FIELD SERVICE BULLETIN

FSB Number: BJCCFSB2004- 74
Author: Fang Hong
Date: March 22. 2004
Total No. Of Pages: 3
Subject: **V878 (TCH) Main and Sub LCD No Backlight**
Model Affected: **V878 (TCH) GSM/DCS**
Level of Repair: 3

PIC1

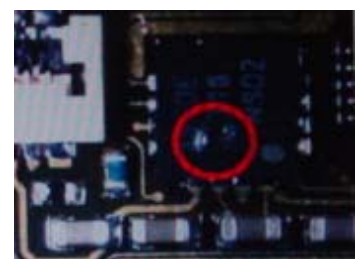
1> The DC-DC convert removed or damaged (PIC1&2).

PIC3

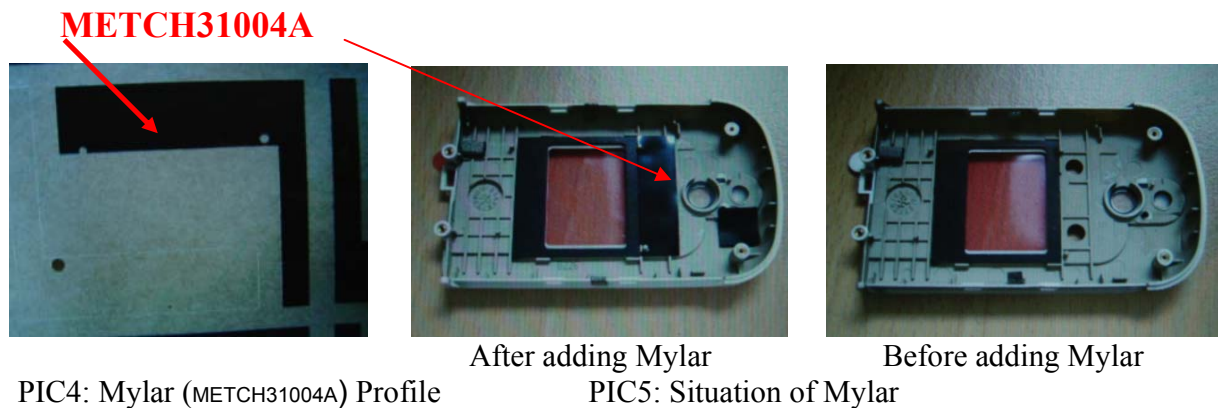
2> A trace beside DC-DC convert was broken (PIC3).

Root cause LCD module damaged is a capacitor on LCD module shortly with front housing (Case A), Inside front housing (Case A) were covered by electric lacquer for EMI, and connect with ground. So large current lead trace broken or DC-DC convert damaged or removed.

Action is add a Mylar in front housing (Case A) to reduce the risk that the component on LCM to contact case A. Mylar's P/N: METCH31004A (PIC4). PIC5 is the situation of Mylar in case A.
